ACEEE Comments to the Environmental Protection Agency and the National Highway Traffic Safety Administration on the Technical Assessment Report; Docket ID No. EPA-HQ-OAR- 2015-0827 and/or Docket No. NHTSA-2016-0068

Figure 1: NHTSA’s technology penetration for selected full size pickups in MY 2028

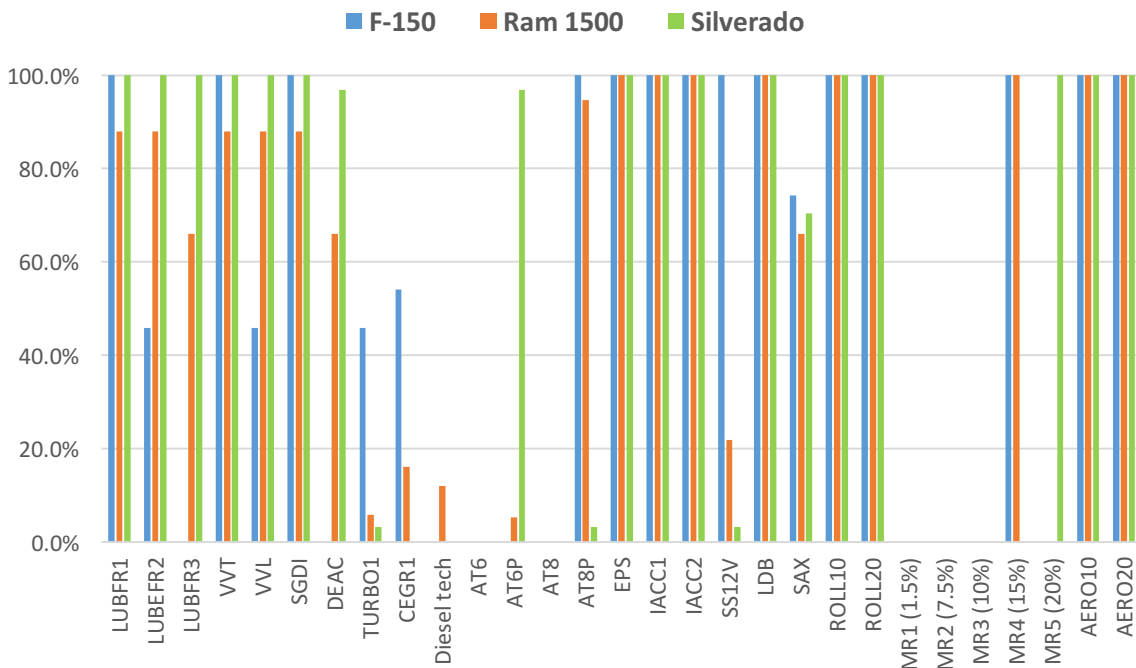
NHTSA’s compliance packages do not appear to show the most cost-effective pathways to compliance. For example, while there are 8-speed transmissions in almost all F-150 and Ram pickups in 2028, only 3% of Silverado trucks have them, the same percentage as in the 2015 baseline fleet. This is all the more surprising given that an 8-speed transmissions is already available in the high-volume 5.3L Silverado in MY 2016 and has been standard in models with the 6.2L engine for years.¹⁰

On the other hand, Volpe outputs show 100% of MY 2028 Silverado trucks with 20% mass reduction in 2028. Mass reduction will play a critical role for compliance for trucks, and all F-150 and Ram trucks, as well as the Silverado, will adopt 15% mass reduction by 2021, according to the model. But NHTSA’s cost estimates for mass reduction increase sharply at higher percent reduction, so increasing mass reduction to 20% in the Silverado before even adopting 8-speed transmissions is not plausible. Increasing mass reduction from 15% to 20% provides 3% fuel savings at a total cost of \$1,000 (p. 5–411), while an advanced 8-speed “plus” transmission (AT8P) gives 9% savings at a cost of \$320 (p. 5–298, p. 5–452).

The NHTSA compliance scenario also shows no hybrids, full or mild, in the F-150, Ram, or Silverado, even 48V mild hybrid provides fuel savings in the vicinity of 10% at a cost of about \$100 per percent fuel savings (pp. 5–301, 5–454). As noted previously, NHTSA does not explain its mild hybrid specifications or any limitations the Volpe model may place on adoption of this technology in the TAR, so it remains unclear why these vehicles do not appear in the
